**PCN#20150605000  
28 PLCC Carrier Tape Change  
Final Change Notification**

**Date:** 6/8/2015  
**To:** MOUSER PCN

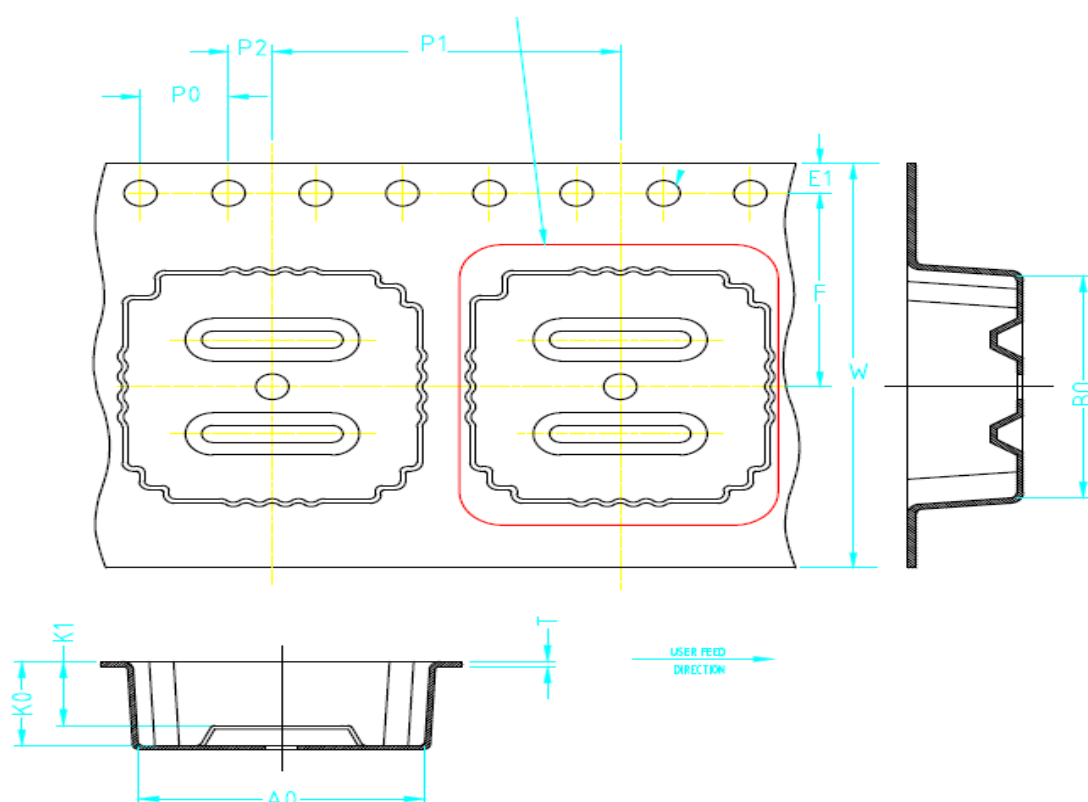
PCN Details		
<b>Description of Change:</b>		
<p>Texas Instruments is pleased to announce the qualification of a new carrier tape for selected devices in the 28L PLCC package. The material composition between the 2 carrier tapes is the same. A comparison summary is below:</p>		
<b>What</b>	<b>From</b>	<b>To</b>
Supplier	Sumitomo	Peak
Color	Black	Black
Design Comparison		
Photo (Top)

Parameters	PEAK			SUMI CARRIER		
	Nominal	* Lower	* Upper	Nominal	* Lower	* Upper
Ao	13.30	13.20	13.40	12.95	12.85	13.05
Bo	13.30	13.20	13.40	12.90	12.80	13.00
Ko	5.00	4.90	5.10	5.10	5.00	5.15
K1	3.80	3.70	3.90	4.10	4.05	4.15
P1	16.00	15.90	16.10	16.00	15.90	16.10
P2	2.00	1.90	2.10	2.00	1.90	2.10
Po	4.00	3.90	4.10	4.00	3.90	4.00
W	24.00	23.70	24.30	24.00	23.70	24.30
T	0.40	0.35	0.45	0.30	0.20	0.40
E1	1.75	1.65	1.85	1.75	1.65	1.85
F	11.50	11.40	11.60	11.50	11.40	11.60
